LANDSCAPE REVIEW OF PLANNING APPLICATION 26/01201/OUT

- 1 This report has been prepared on behalf of Winchfield Parish Council (WPC) and Hook Parish Council (HPC) in response to planning application 26/01201/OUT. The application seeks outline permission, with all matters reserved except access, for a phased residential-led mixed-use development of up to 2,160 dwellings together with employment, local centre, community, education, green and blue infrastructure, Suitable Alternative Natural Green Space (SANG) and associated works.

Figure 1 - Additional viewpoints location

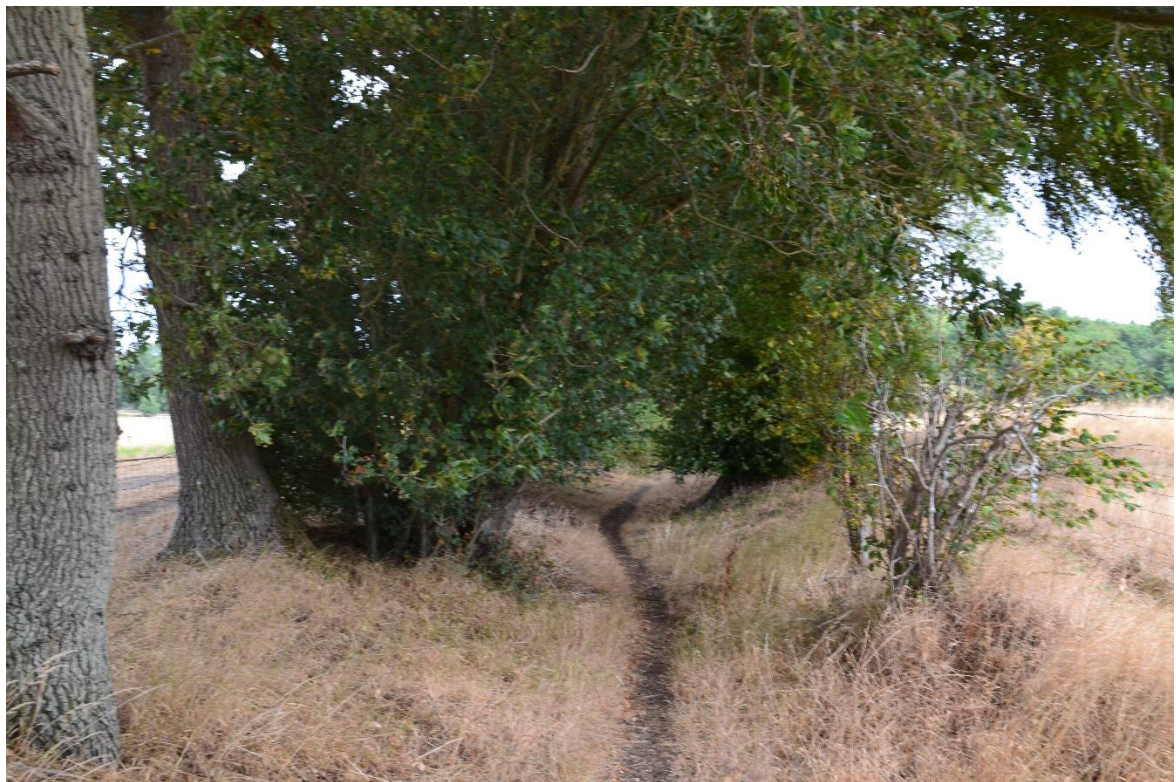
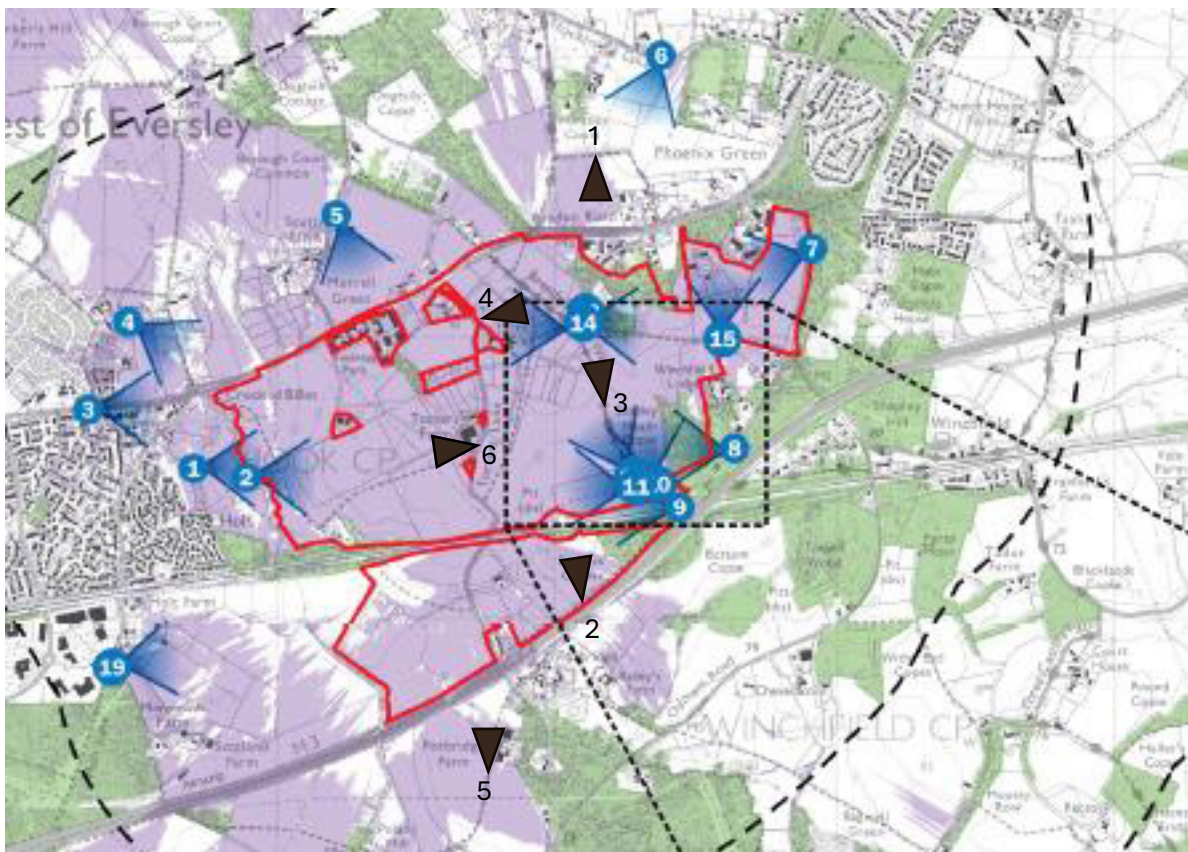
- 2.17. The viewpoint set does not adequately represent all relevant receptors or the way the landscape is experienced in motion. The following omissions should be addressed (Figure 1):

- PRoW 107/29/1, Hartley Wintney (Viewpoint 1): A relevant elevated/longer-distance public receptor from which the development may be perceived; absent from the submitted set.

- PRoW 178/23/1, Odiham (Viewpoint 2): The proposal is visible from this route, indicating a wider landscape influence greater than the LVIA's Negligible Year 15 conclusion.

- Brenda Parker Way (Viewpoint 3): Viewpoints are concentrated only on the Neighbourhood Plan Key Views and do not provide sufficient intermediate views to record the sequential open/enclosed experience through the Site.

- Totters Lane (Viewpoint 4): No representative viewpoint is included despite the route being assessed as a visual receptor.
 - Winchfield PRoW 254/501/1 (Viewpoint 5) : No representative view along the route/SANG context tests development remaining visible in the background or the effect of the proposed 30 m motorway woodland buffer.

- Hook PRow 117/5/1 (Viewpoint 6): No representative viewpoint is included despite the route being assessed as a visual receptor.
- Hook PRow 117/6/1: No representative viewpoint is included despite the route being assessed as a visual receptor.

2.18. The missing views are not merely a presentational gap. They affect the understanding of the development's spread, the loss of rural outlook, increased visual disturbance and the consequences for landscape character. A thorough assessment should include winter (where possible) and summer photography, verified wirelines or photomontages where appropriate, and a route-based narrative for the Brenda Parker Way and other affected PRowS.

- provide night-time effects and a reasonable worst-case levels envelope;
 - add representative and sequential viewpoints from the omitted PRowWs, Totters Lane and the full Brenda Parker Way route;
